STAFF REPORT

TO: Committee of the Whole **MEETING DATE:** March 25, 2014

FROM: André Boel, Director of Planning **FILE NO:** 3220-20 Gower 377-385
Odete Pinho, Planning Consultant ZA-2013-01

SUBJECT: George Hotel & Residences – form and character

Figure 1a - Change in Gower Point Road Façade South Elevation

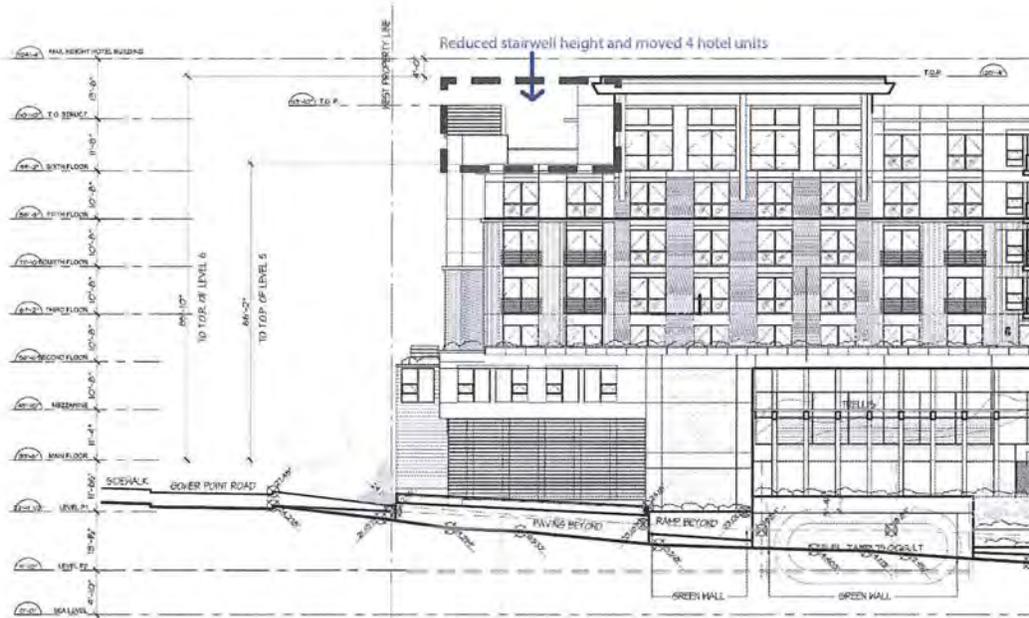
Figures 1a: Change in Gower Point Rd Façade / Four Units moved to waterfront level P1 (in response to APC recommendation 2: "increased stepping back or terracing following the natural grade and addressing the hotel façade on Gower Point Road")

Figure 1b - Change in Gower Point Road Facade
Gower Point Road Elevation

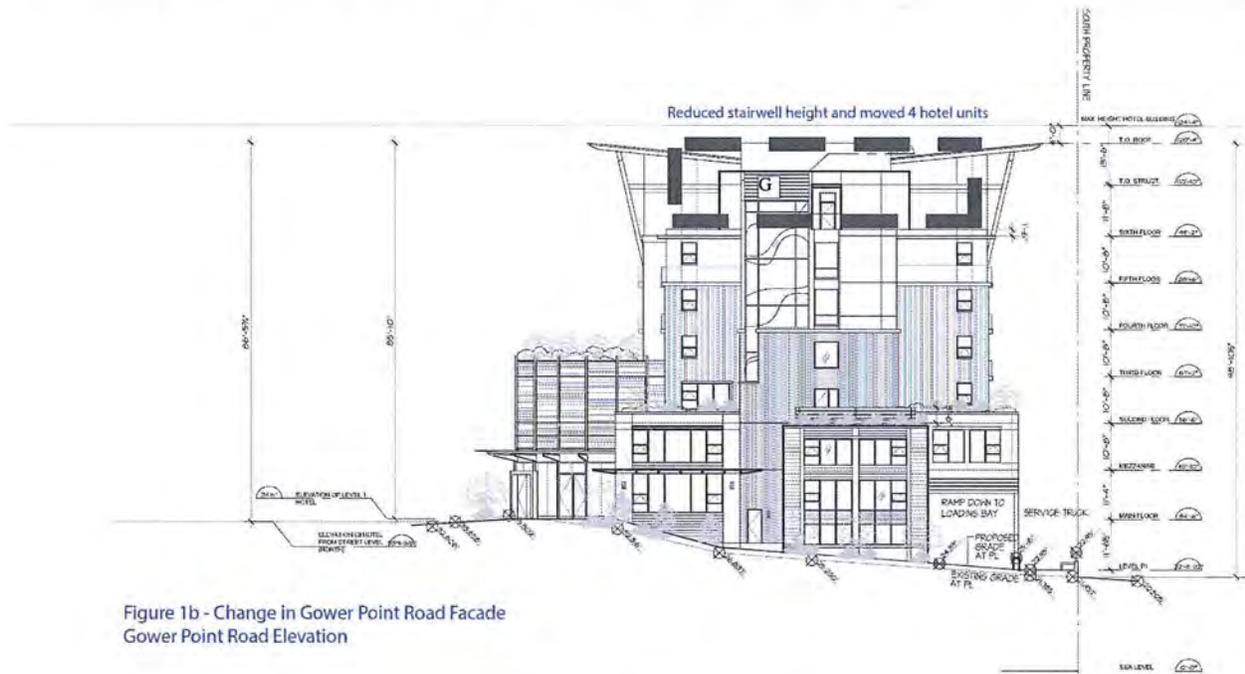
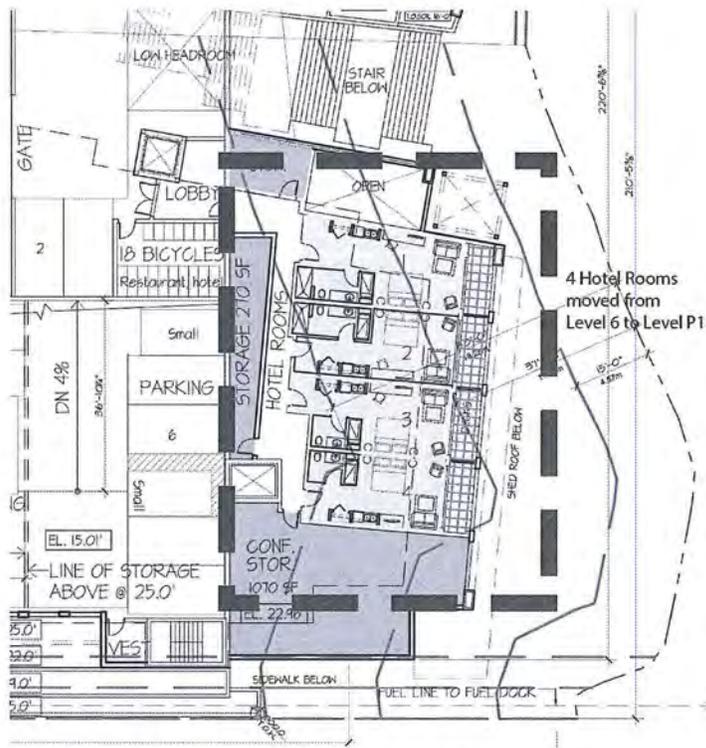
Figures 1b and c: Change in Gower Point Rd Façade / Four Units moved to waterfront level P1 (in response to APC recommendation 2: “increased stepping back or terracing following the natural grade and addressing the hotel façade on Gower Point Road”)

Figure 2a- Stepping on Gower Point Road

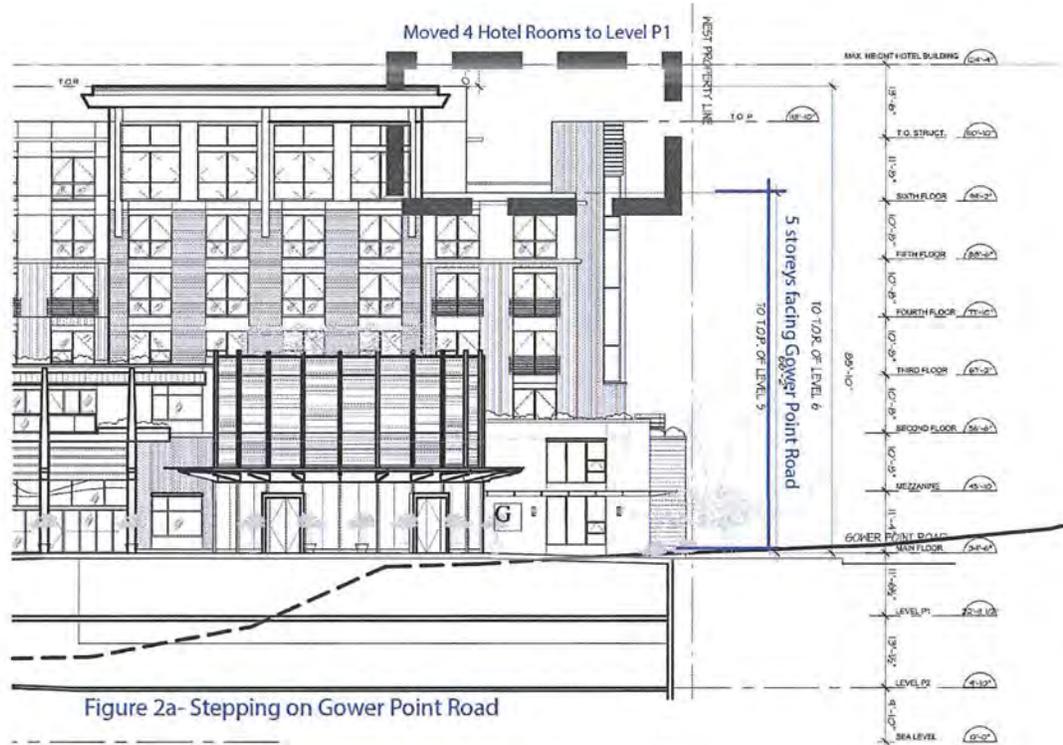
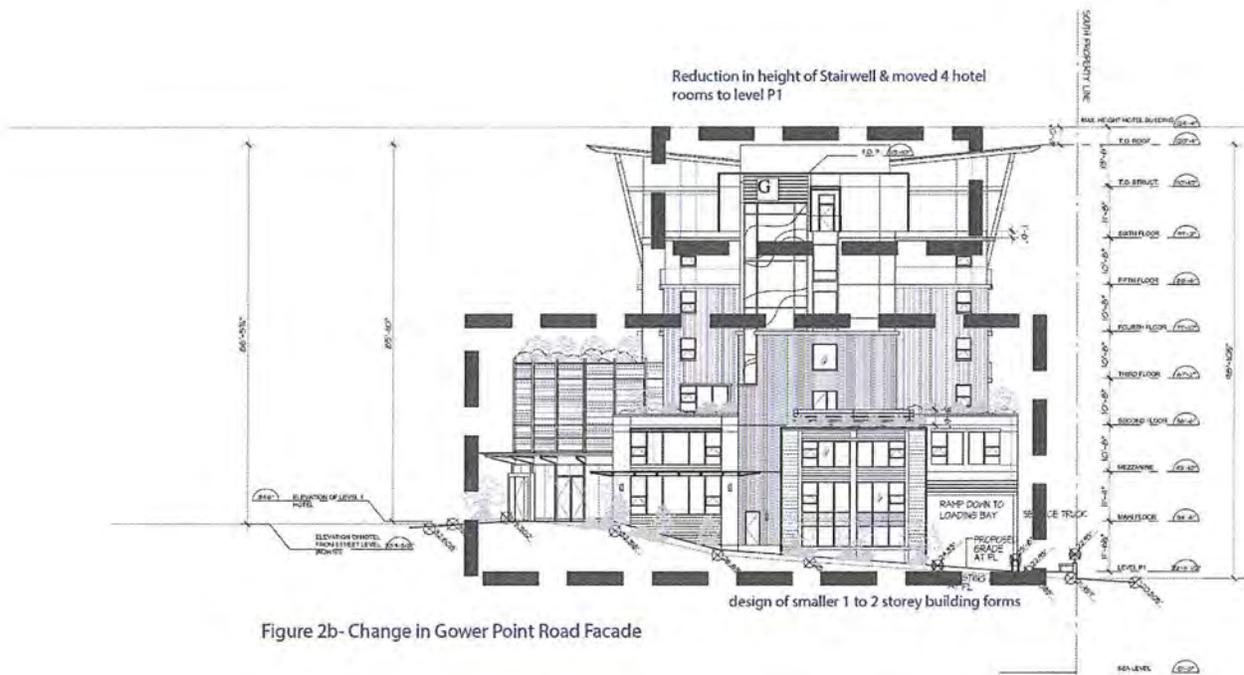
Figures 2a and b: Change in Gower Point Rd Façade / Four Units moved to waterfront level P1 (in response to APC recommendation 2: “increased stepping back or terracing following the natural grade and addressing the hotel façade on Gower Point Road”)

Figures 5-10: Visualization Images (top to bottom; left to right) from: Smitty's Restaurant; Wharf Gazebo; Winn Rd at Abbs; Headlands Rd Beach; Holland Park Stairs; Gower Point Road. Please note: these visualisations do not show the proposed colours and materials.

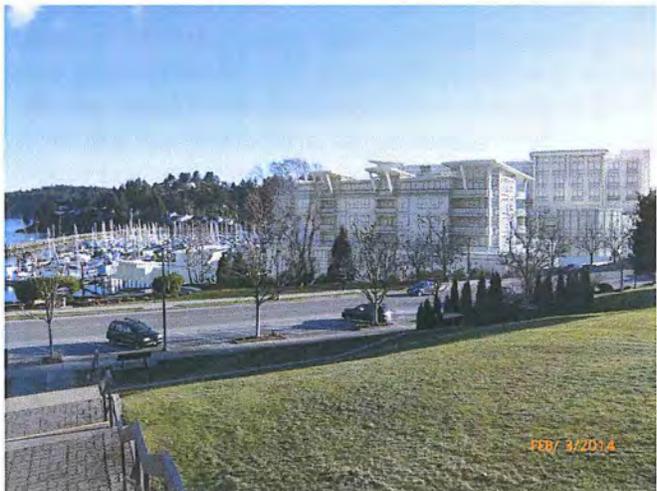
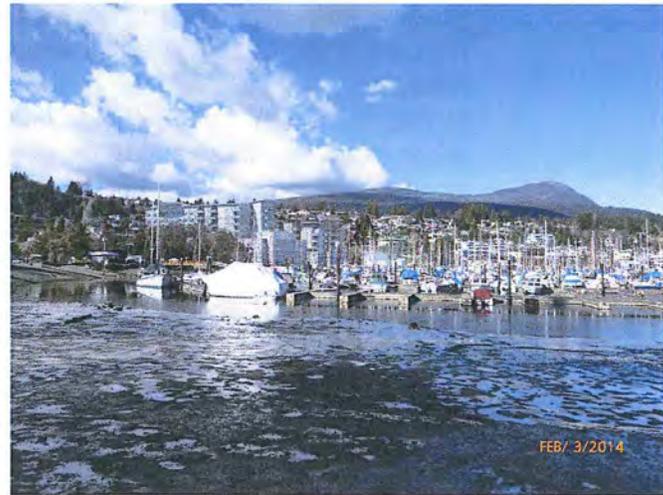
The visual assessment images were produced for six view overlays of the proposed hotel and residences onto the provided photos. Omicron, the development applicant's architect, provided a proposed development computer massing model. Accuracy of mass and height was achieved by matching the viewpoint, the camera focal length and the lens target to the provided model. The resulting renderings reflect, as accurately as possible, the on-site massing.

The visual assessment images presented in this report are an accurate representation of the mass and height for the proposed development project, as it would be seen from the view points at eye-level. It should be noted that the digital model images did not include architectural materials and colours that would reflect the design 'look and feel' of the development. Instead, the visualization shows only the correct mass of the proposed development in relation to the existing surrounding area.
